**Response to the "Notice of Disapproval for the
Investigation Work Plan for Upper Cañada del Buey Aggregate Area,
Los Alamos National Laboratory EPA ID No: NM0890010515, HWB-LANL-08-013,"
Dated August 28, 2008**

INTRODUCTION

Attachment 1
Engineering Drawing C-38763

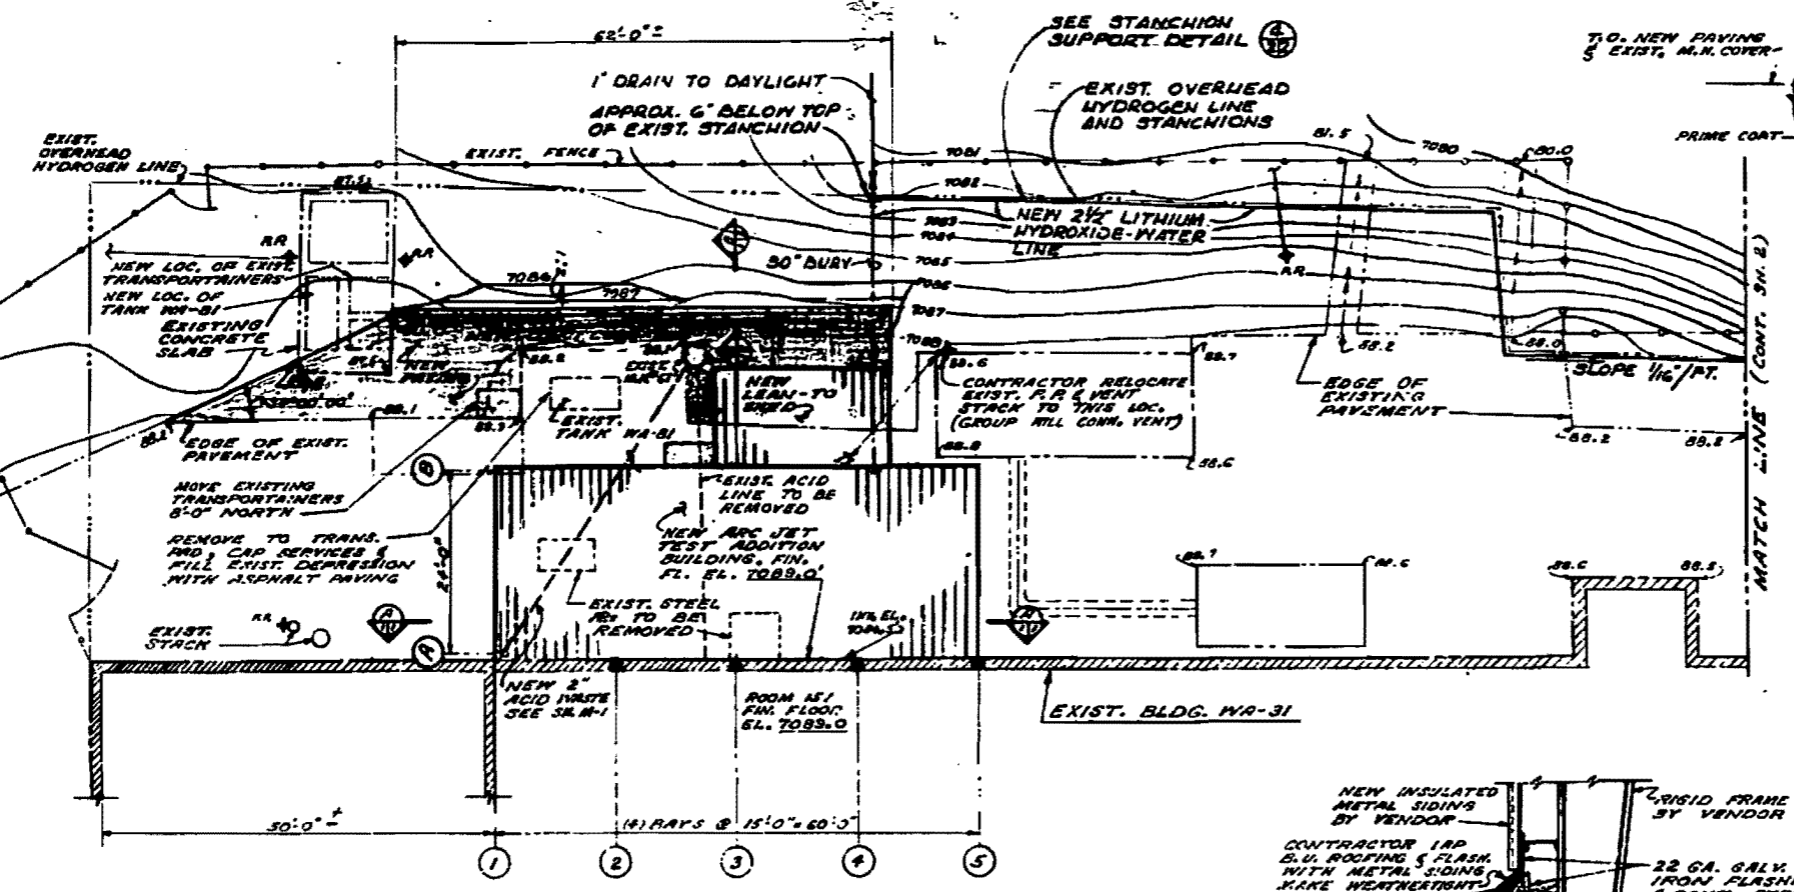
NMED Comment: Section 5.2.2 of the June 1996 RFI Report for Potential Release Sites in TA-46 (1996 RFI) indicates the former tank historically occupied at least two locations at SWMU 46-004(b). Review of Figure 5.2.2-1 of the 1996 RFI indicates neither of the historical tank locations shown on that figure correspond with the location shown on Figure 5.5-1 of the Plan. The Permittees must explain why the tank location shown in the Plan figure differs from the locations shown on the 1996 RFI figure.

5. Figure 5.5-1 of the work plan shows the original (operating) location of the SWMU 46-004(b) alkali-metal cleaning tank but does not show the second (staging) location. The location of the tank as shown in Figure 5.5-1 is based on the location shown in engineering drawing C-38763 (Attachment 1). The tank location depicted in the 1996 Resource Conservation and Recovery Act

(RCRA) facility investigation (RFI) report figure showing it to be directly next to building 46-31 is incorrect.

As shown in the 1996 RFI report figure, the tank occupied a second location for a short period of time (LANL 1996, 054929). In 1970–1971, during the construction of the Arc Jet Test addition at building 46-31, the tank was emptied, disconnected from piping, and moved to an existing concrete pad located approximately 15 ft northwest of the original tank location. Engineering drawing C-38763 (dated September 14, 1970) directs that the piping to the tank be capped and provides no direction for installing piping at the tank's new location, indicating that the tank would no longer be used. As is common practice in many technical areas throughout the Laboratory, equipment removed from service is often placed at a convenient outside location until the items can be removed for disposal. The tank was staged at this location until it was removed for disposal in 1973.

The second location of the tank was used only for staging the tank before it was removed off-site. The tank did not operate during the time it occupied this location. Therefore, LANL did not indicate the second location of the tank on Figure 5.5-1, and sampling at this location is not necessary.
